Draft Wilton Town Centre Precinct Rezoning

Draft Wilton Town Centre Precinct Rezoning

Figure 3: Centres Hierarchy

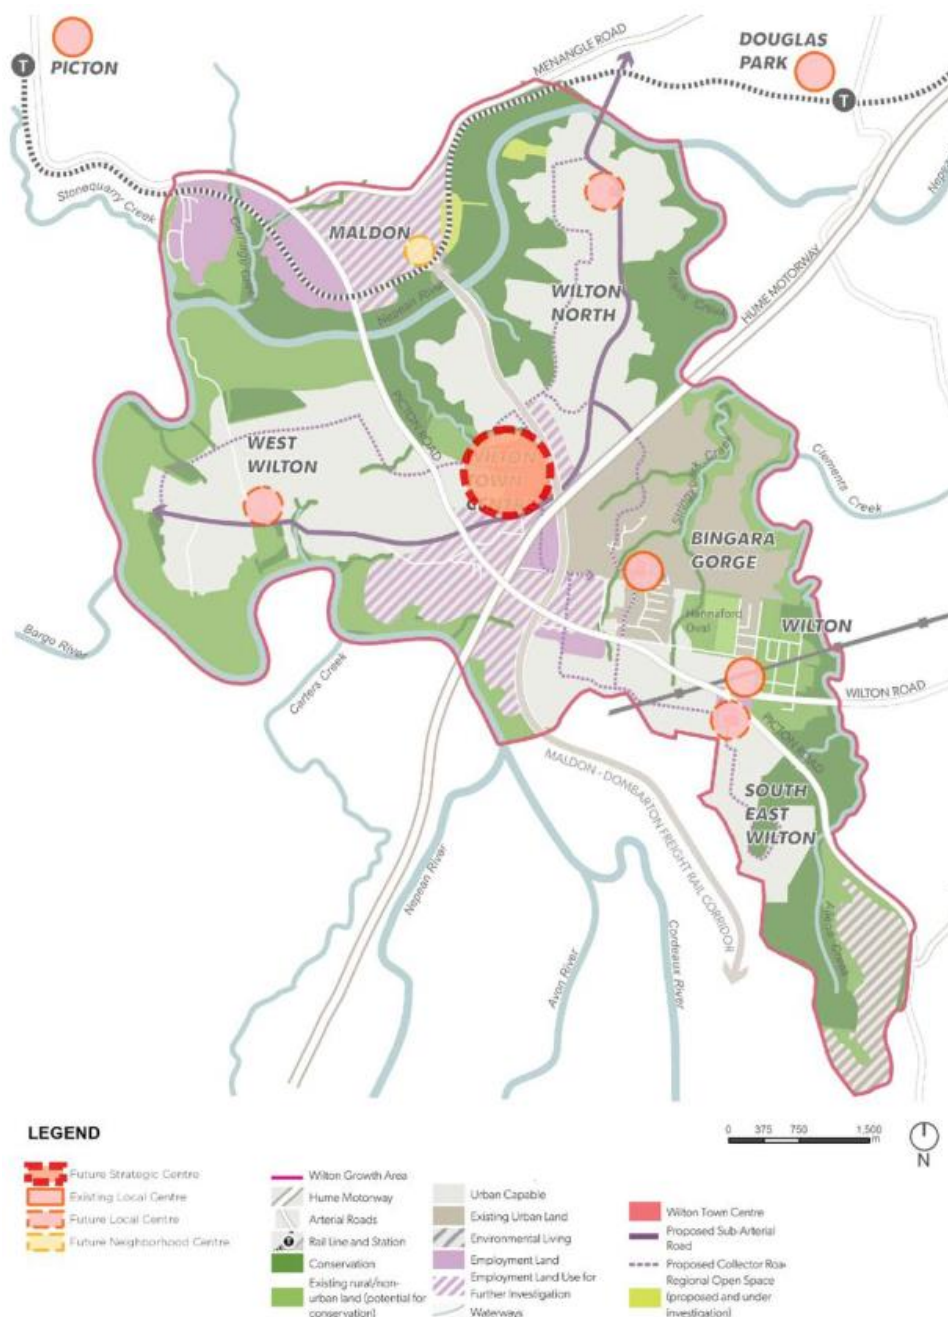
Table 2 of the Part 6 Employment DCP sets out the role and function of each of the centre types. Importantly, Table 2 indicates that a total capacity of 20,000m² of retail GFA has been identified for local centres outside of the Town Centre Retail Core. This includes the Local Centres in the north of the North Wilton Precinct, West Wilton and the South East Wilton Precinct.

However, Table 2 fails to recognise the Lakeside Hub located in the North Wilton Precinct. Situated on the proposed Lake, the Lakeside Hub forms a critical component of the North Wilton Precinct, and its vision to create a unique community and recreation focal point. The Lakeside Hub is identified in the adopted North Wilton Structure Plan (refer to Figure 4), which also identifies the 5,000m² retail GFA limit.

- Amend Table 2 of the draft Part 6 Employment DCP that recognises the Lakeside Hub and its role and function as a 'centre'.

FIGURE 13

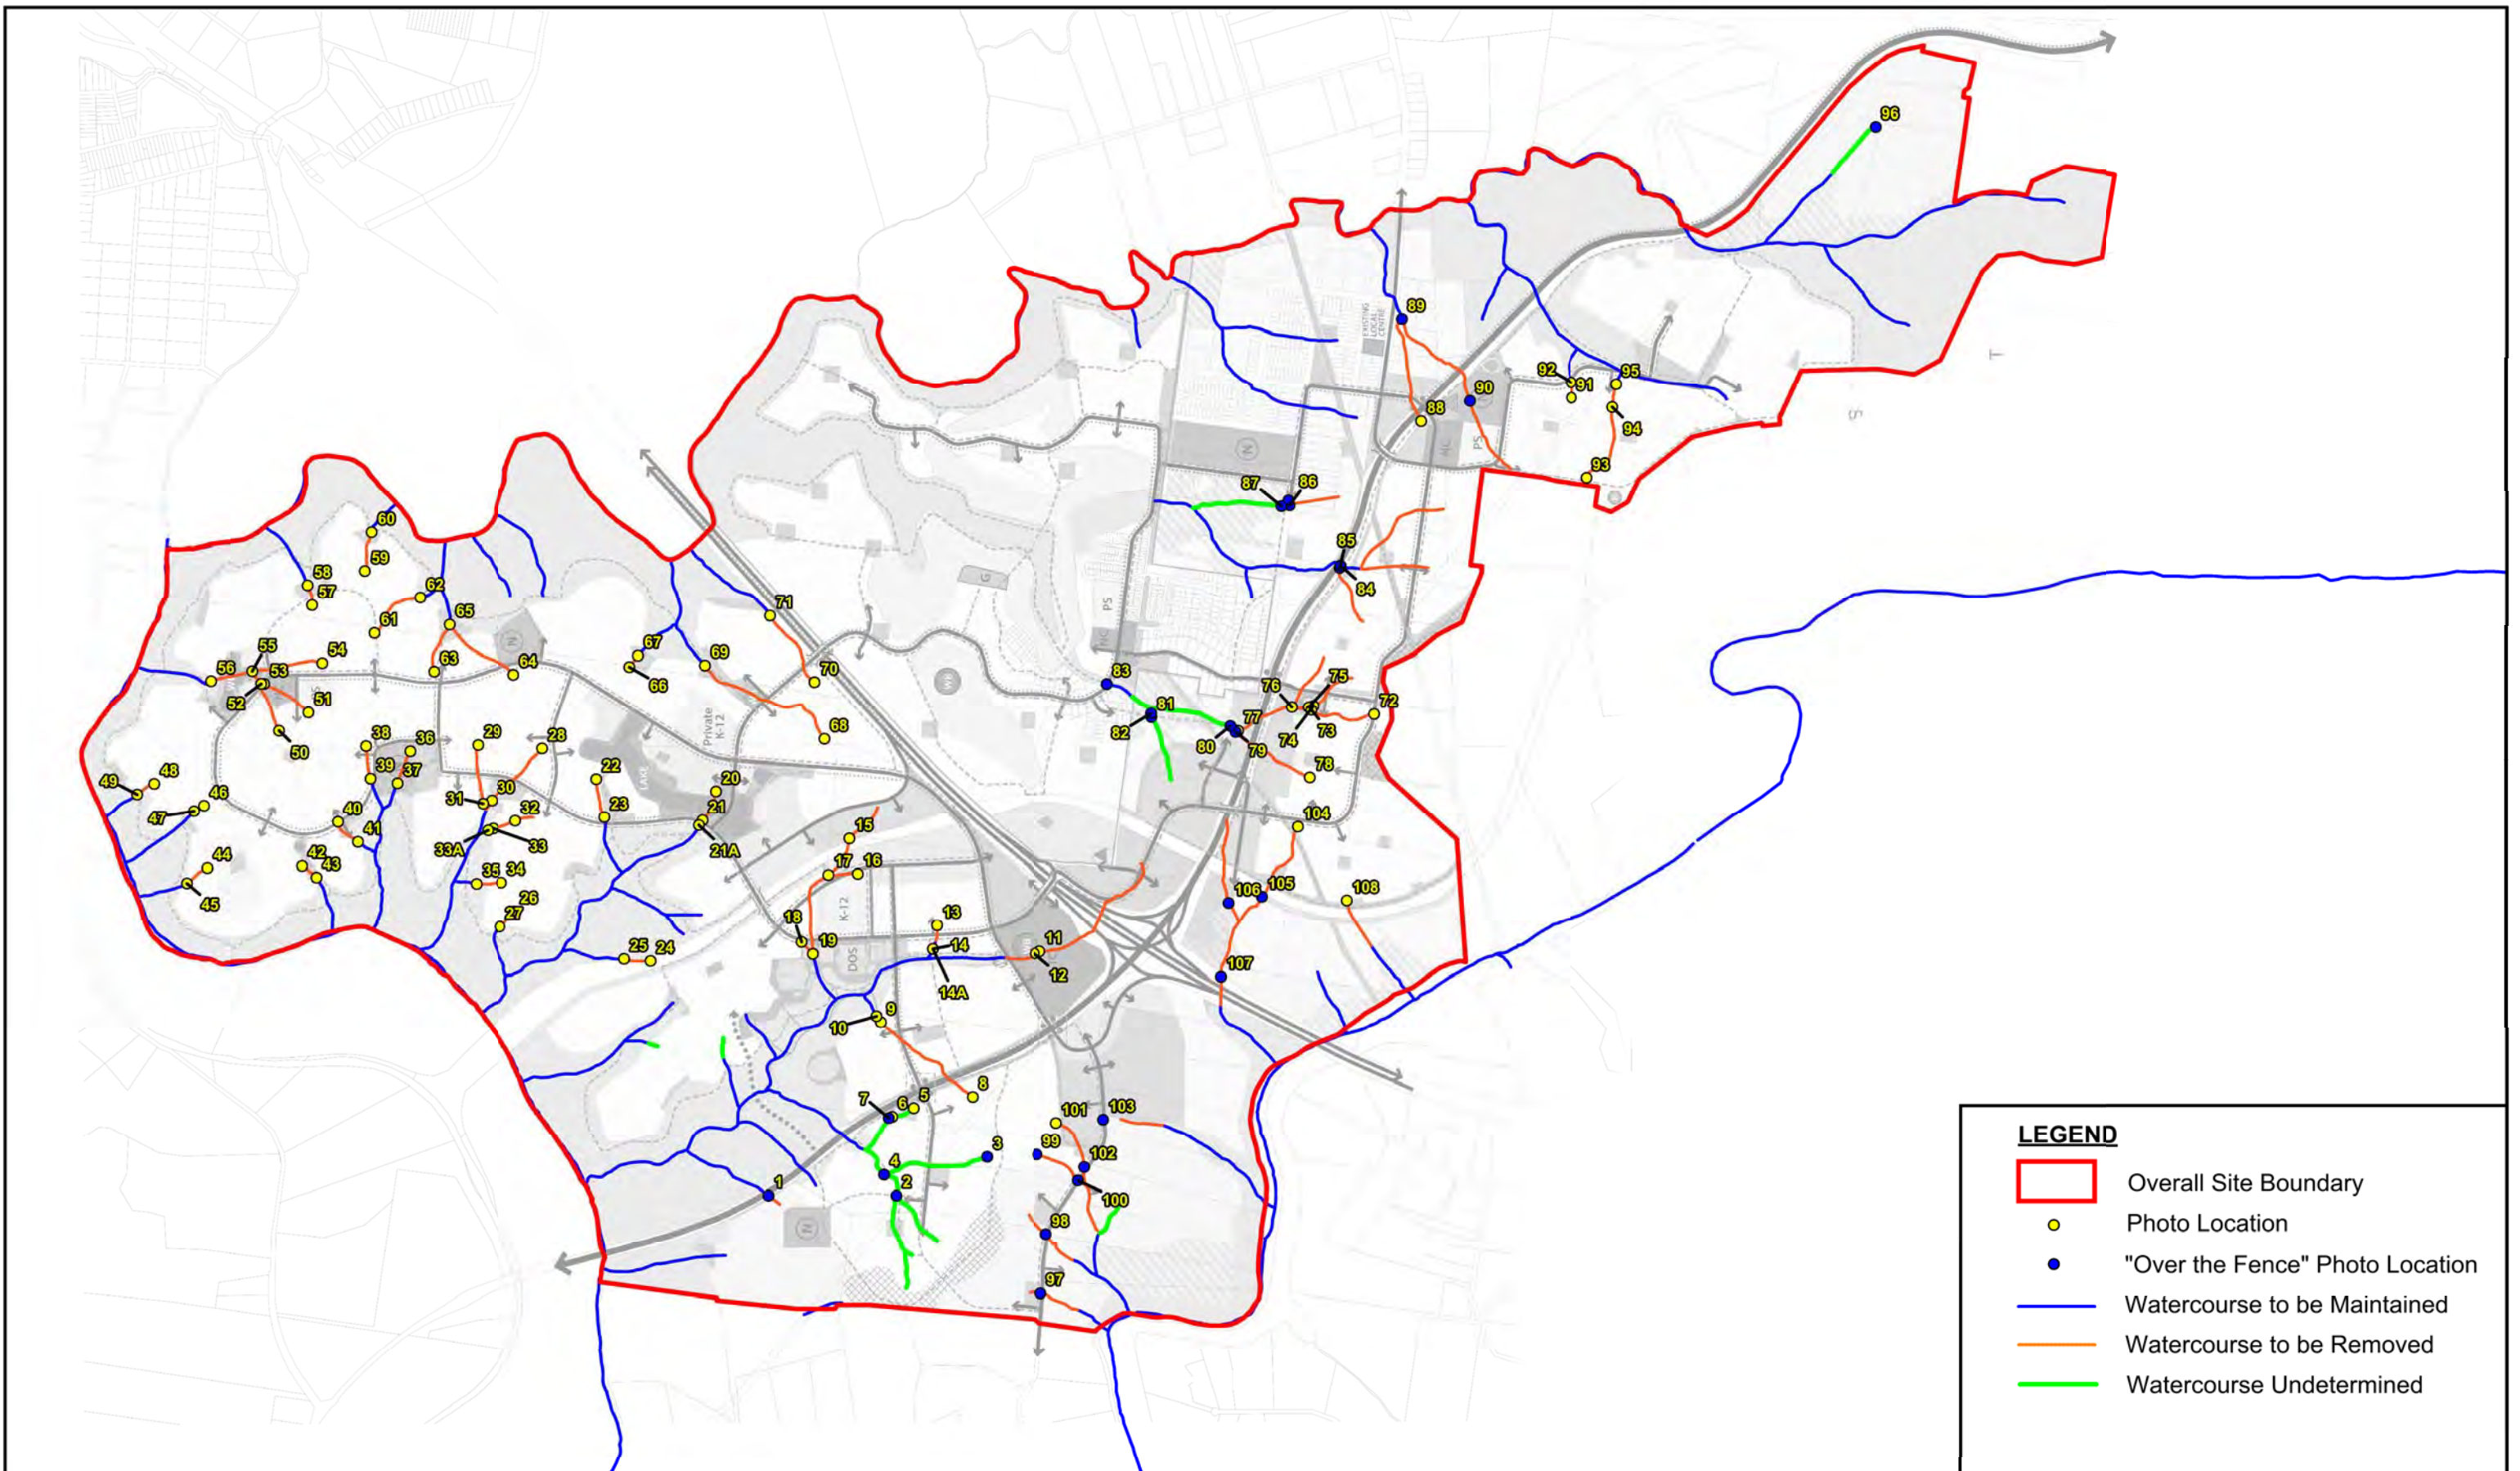
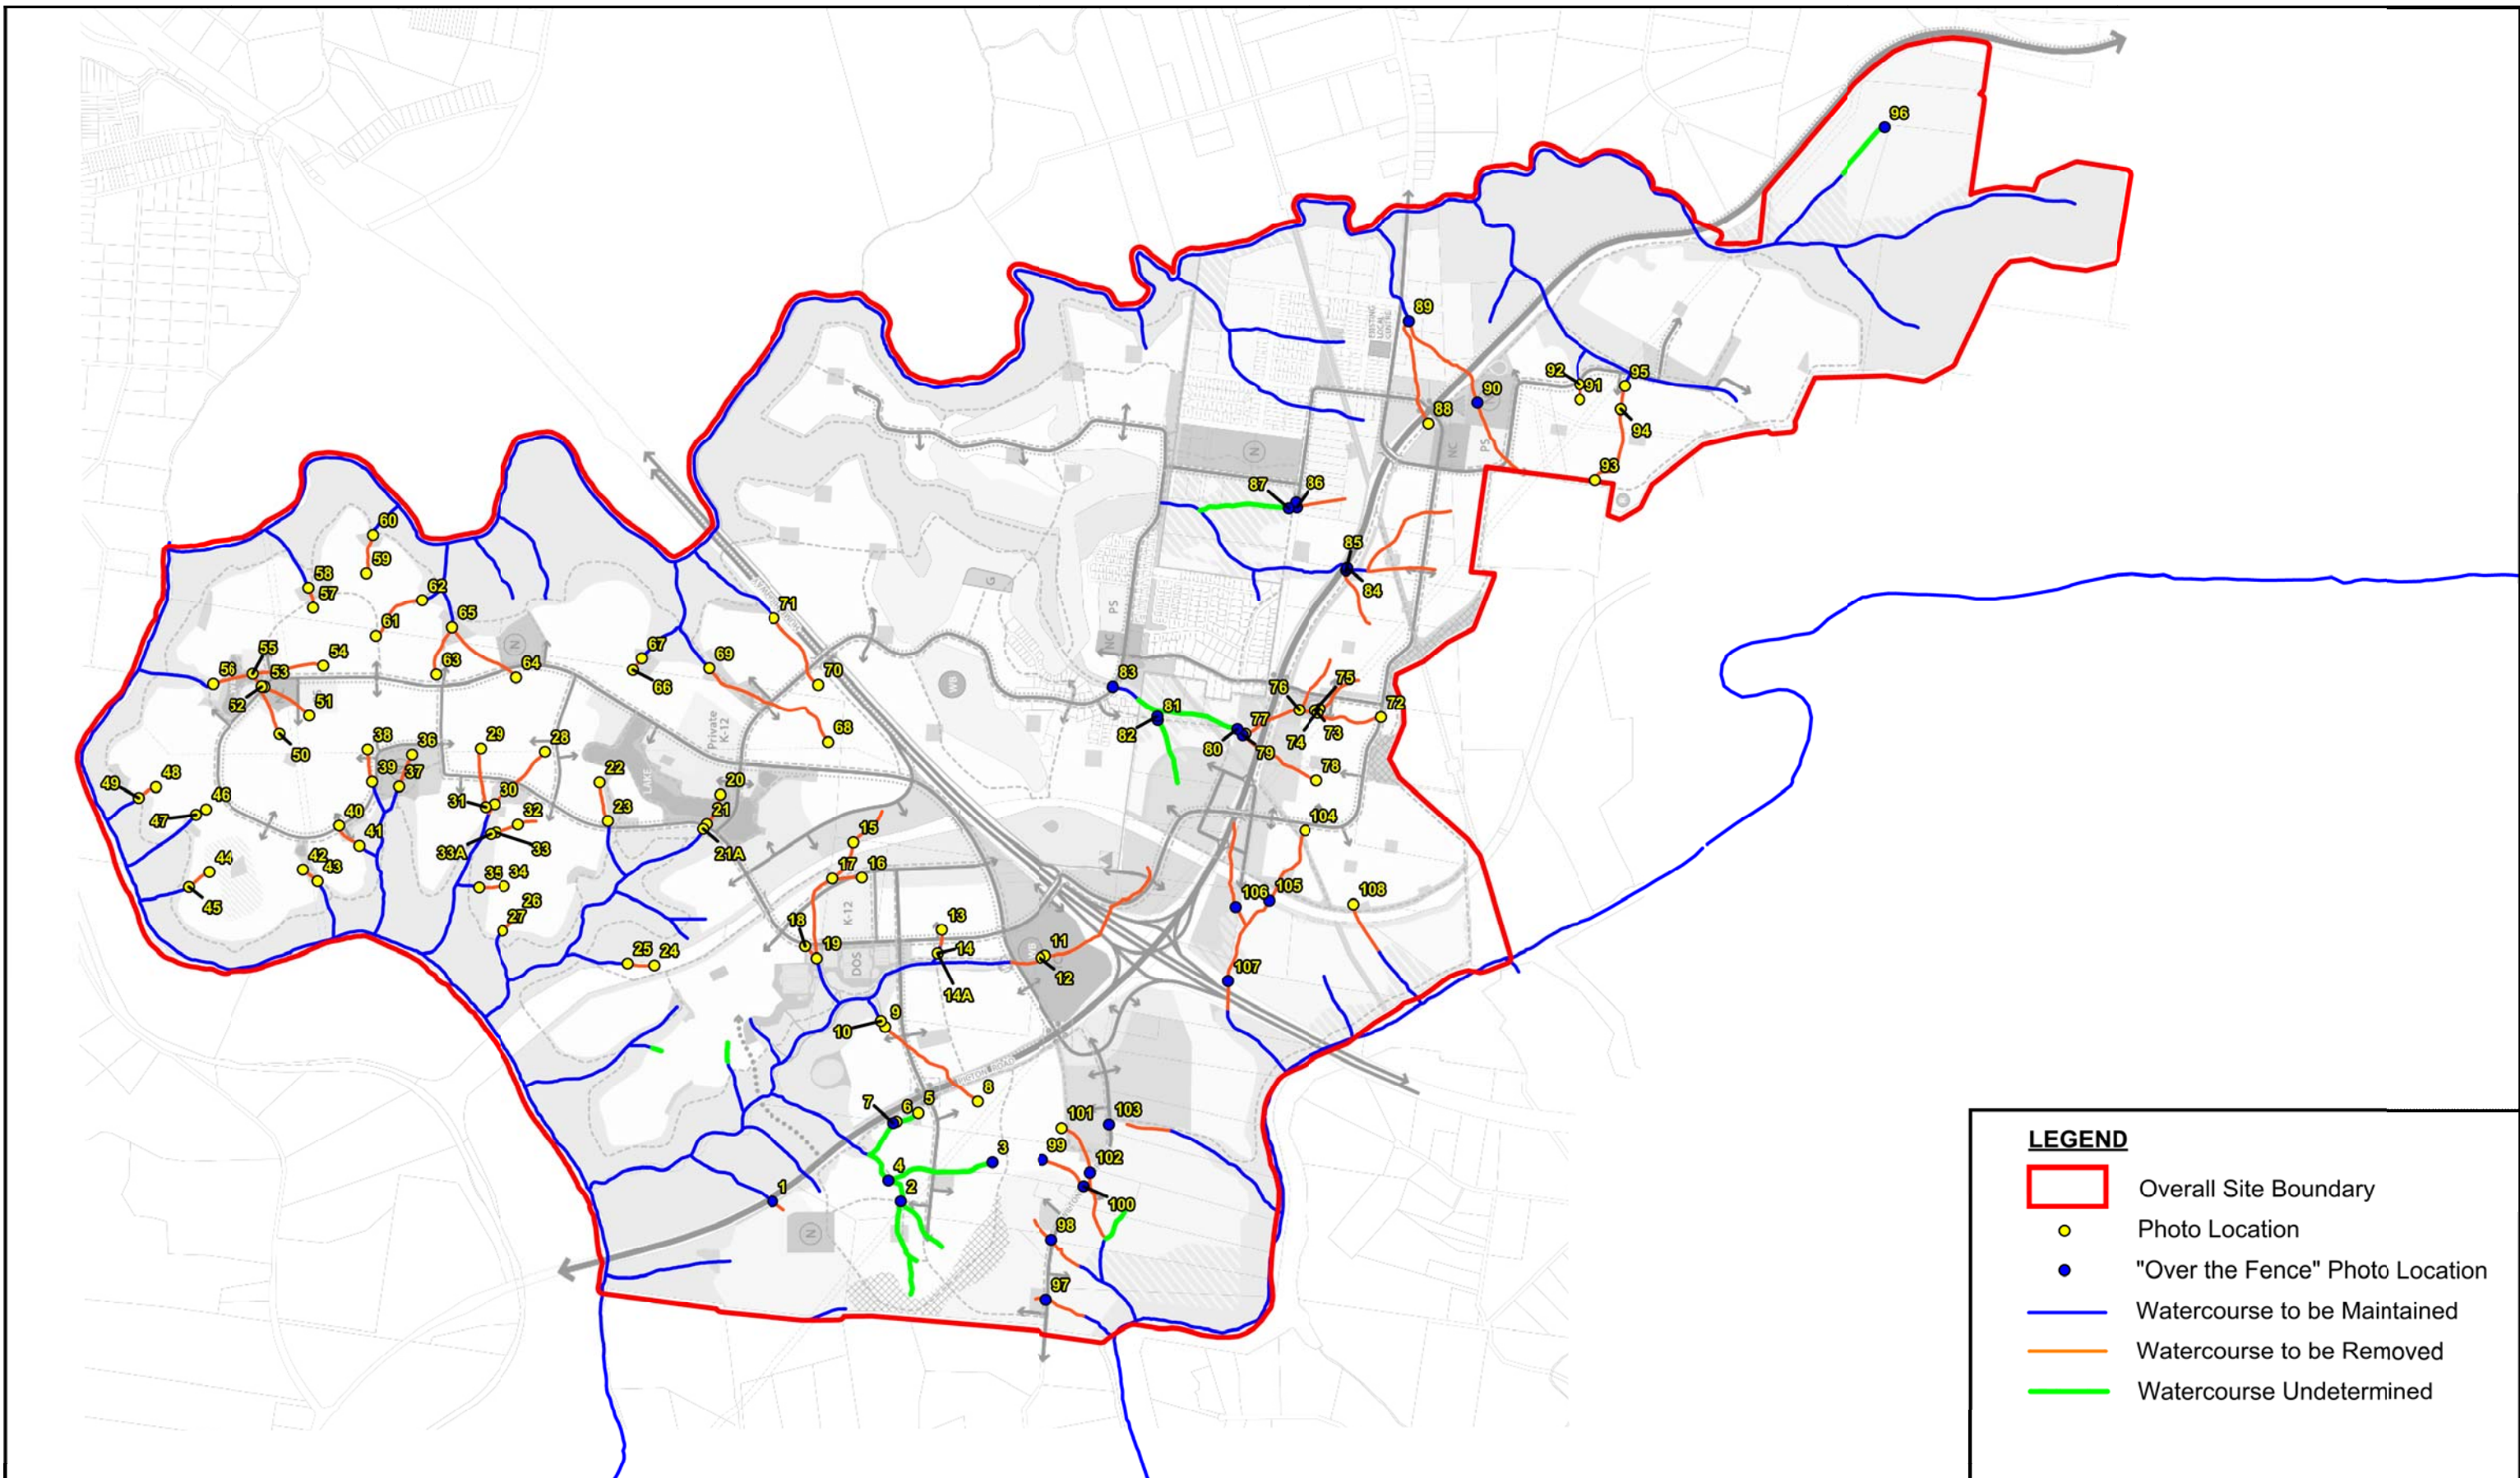
Water NSW agreed to the determination of water courses 15 to 19 and 50 to 56 in Figure 13 as not being waterfront land and can be removed.

The map provided in Figure 13 identifies watercourses to be retained or removed. The figure shows the retention of a number of reaches determined not to be rivers within the stream assessment report. Further clarification is required within the report to confirm whether all retained watercourses as defined by blue lines in Figure 13 will be managed as Waterfront Land in accordance with the NSW Office of Water Riparian Corridor guidelines.

(Original Map top, Suggested changes to map below)

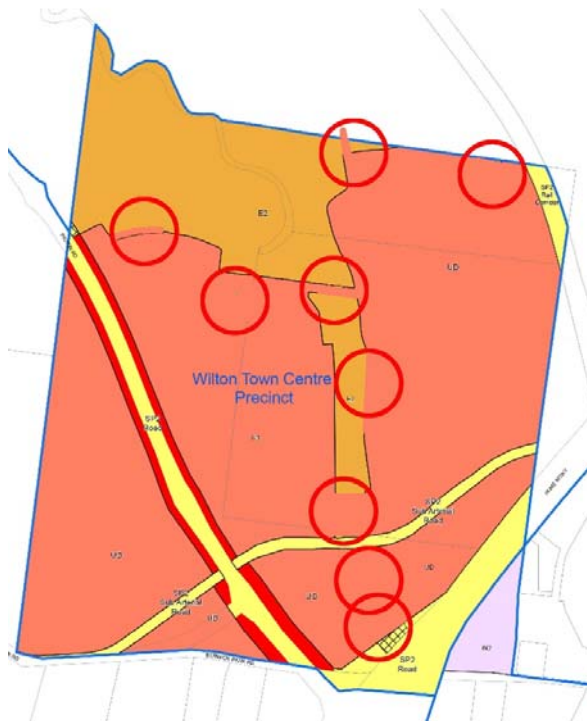
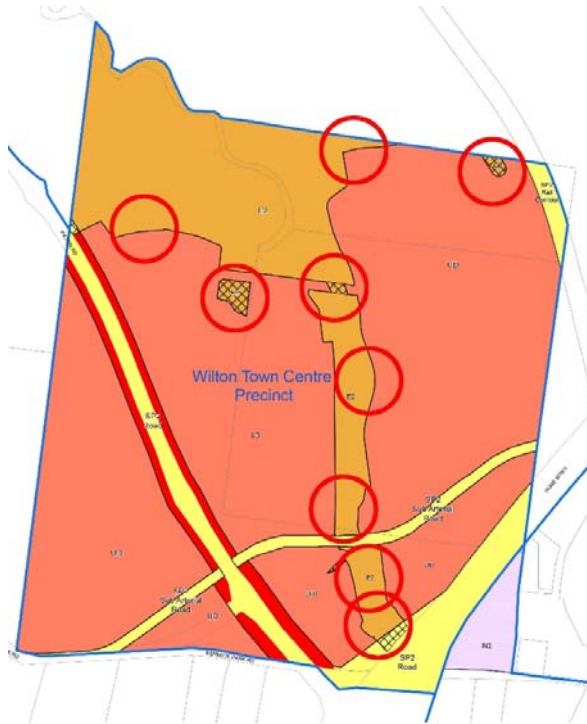
Changes Requested to Zoning map
